**AGENDA  
PLANNING COMMISSION  
116 WEST NEEDLES  
BIXBY, OKLAHOMA  
October 21, 2013 6:00 PM**

**To:** Bixby Planning Commission  
**From:** Erik Enyart, AICP, City Planner *EE*  
**Date:** Thursday, October 17, 2013  
**RE:** Report and Recommendations for:  
PUD 80 – “Wood Hollow Estates” – Sack & Associates, Inc., and  
BZ-367 – Sack & Associates, Inc.

### PROPOSED UTILITY LAYOUT

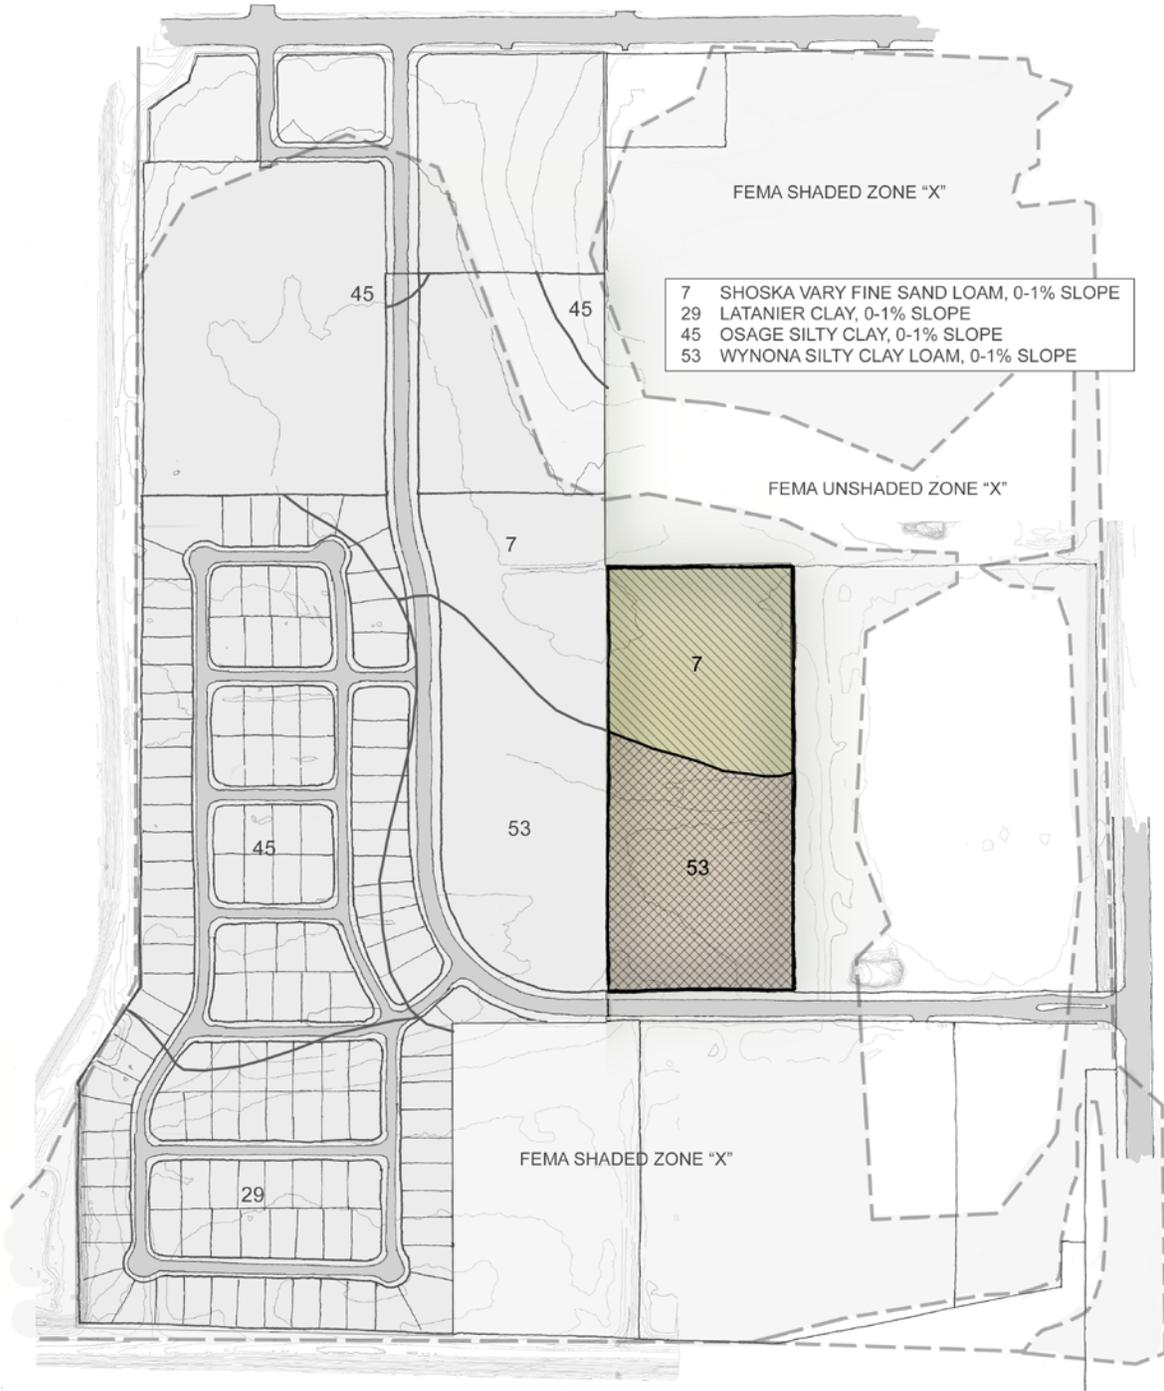
The subject property appears to presently be served by the critical utilities (water, sewer, electric, etc.) and has immediate access to the stormwater drainage capacity in the Fry Creek Ditches abutting to the west and south. Plans for utilities are indicated on Exhibit F and are discussed in the City Engineer's memo.

**Illuminated Pylon Sign - (Qty. 1)**

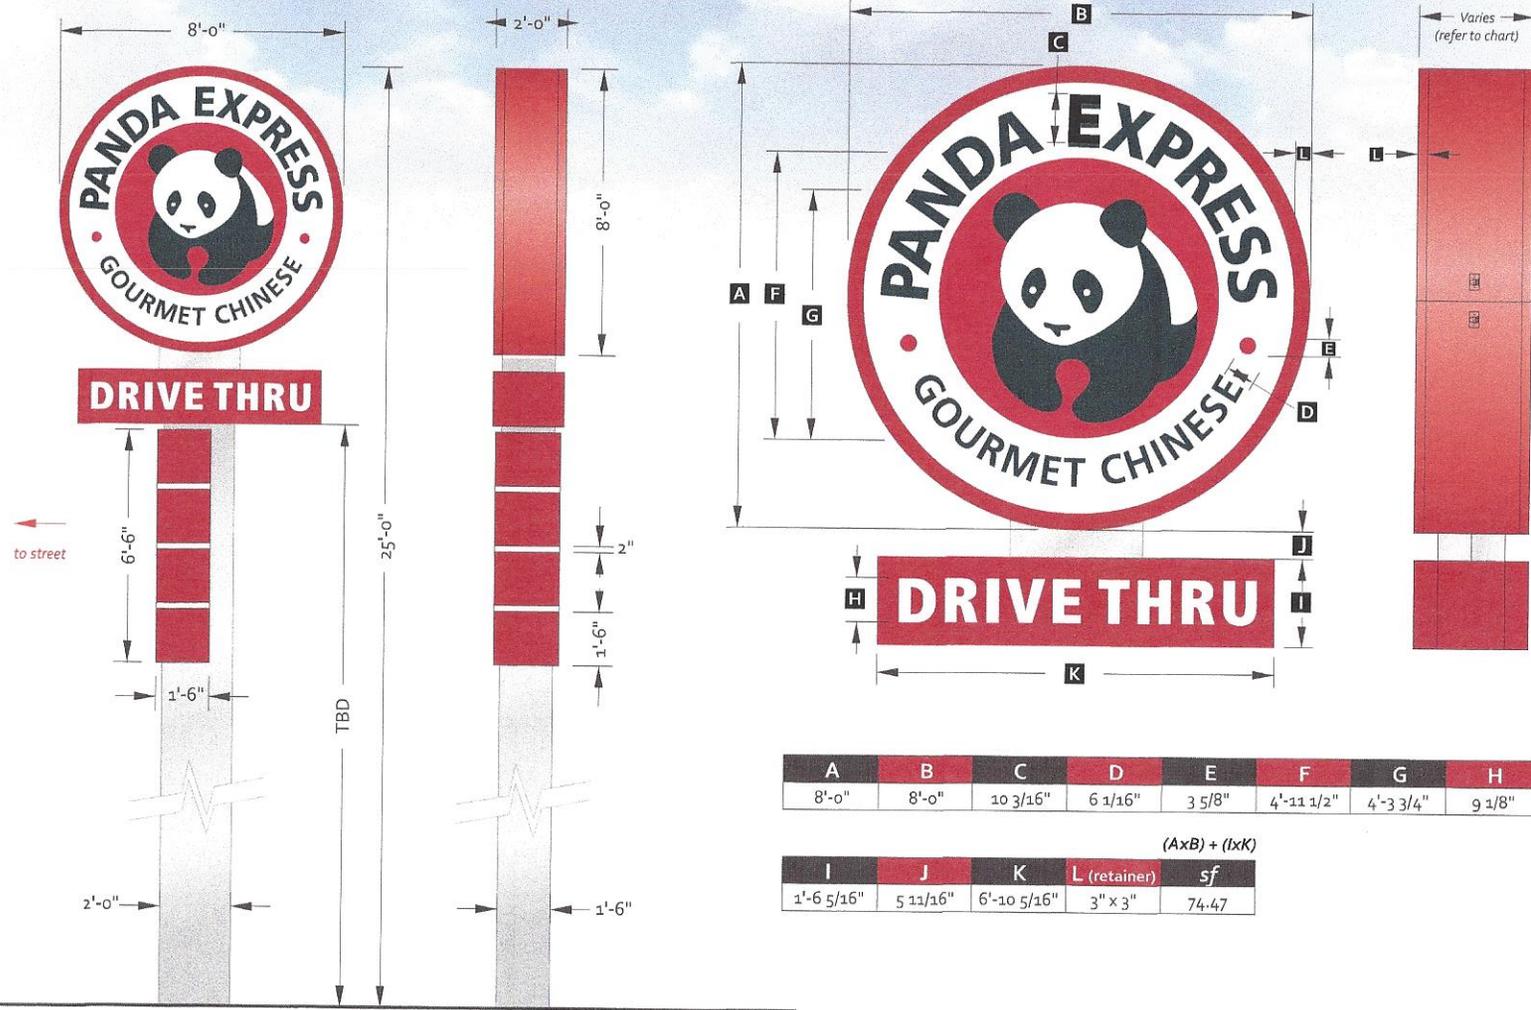
Per the signage drawings, the proposed ground sign is 25' in height. The Zoning Code would allow up to 25' by right, and thus it is the PUD itself which restricts the sign height. Ground signs in the area, especially those for fast-food and sit-down restaurants, typically have signs at or about the 25' height maximum (in PUDs) or 30' maximum (outside PUDs).
